Service Bulletin

Bulletin No.: P11326

Subject: Rear Doors Passive Entry Switch Inoperative

Models: 2015 Chevrolet Impala
Equipped with Passive Entry (RPO ATH)

3973485

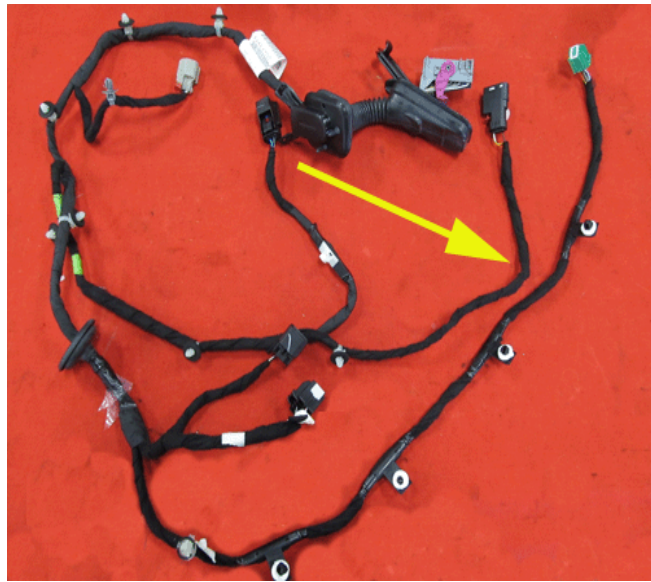
If the passive entry connector terminal(s) are pulled out or not retained properly in the connector (A24RR or A24LR) as shown above, replace both rear door harnesses and modify the new door harness prior to installing. Follow the instructions listed below:

3973684

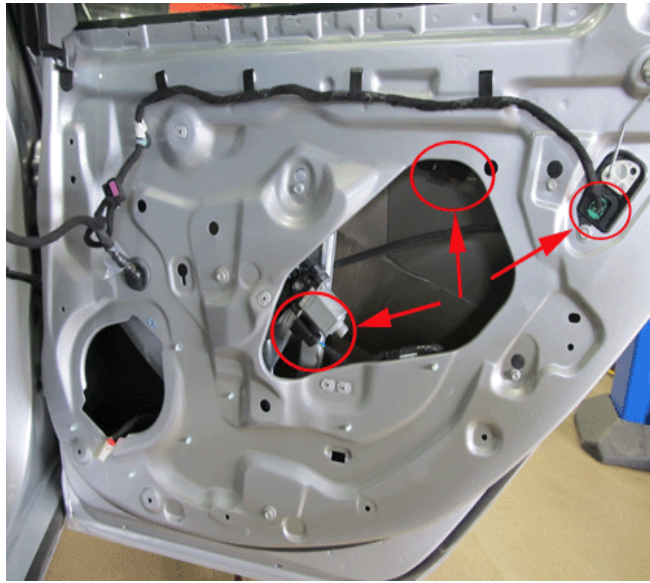
- From the end of the connector to the first push-in retainer is 290 mm. The new retainer must be installed 20 mm from the original retainer away from the connector.
1. Measure 20 mm away from the connector and install a new retainer, P/N 19130464 or equivalent. Remove the original retainer after the new retainer is installed.
 2. Remove the rear door trim panel. Refer to the Rear Side Door Trim Replacement in SI.
 3. Remove the door speaker.
 - 3.1. Remove the speaker fastener.
 - 3.2. Disconnect the electrical connector.
 - 3.3. Unclip the harness retainer.
 4. Remove the water deflector.

3973902

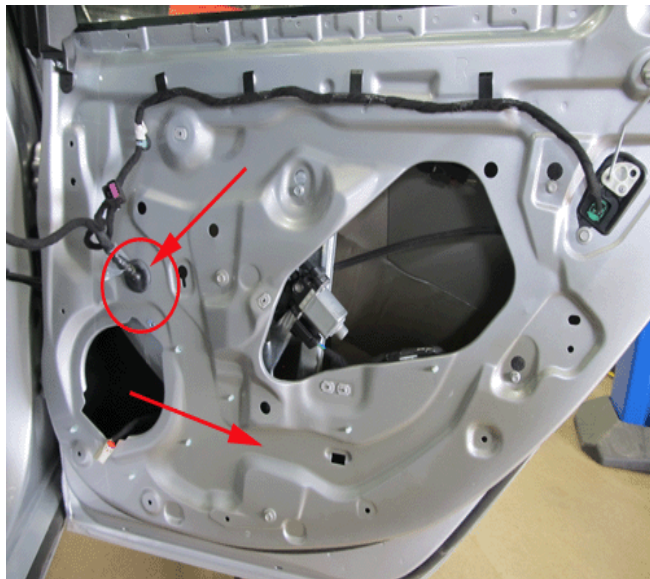
5. Disconnect the 3 electrical connectors.
6. Disconnect the electrical connector X700 (left side) or X800 (right side).
7. Disengage all push-in retainers attached to the door harness.
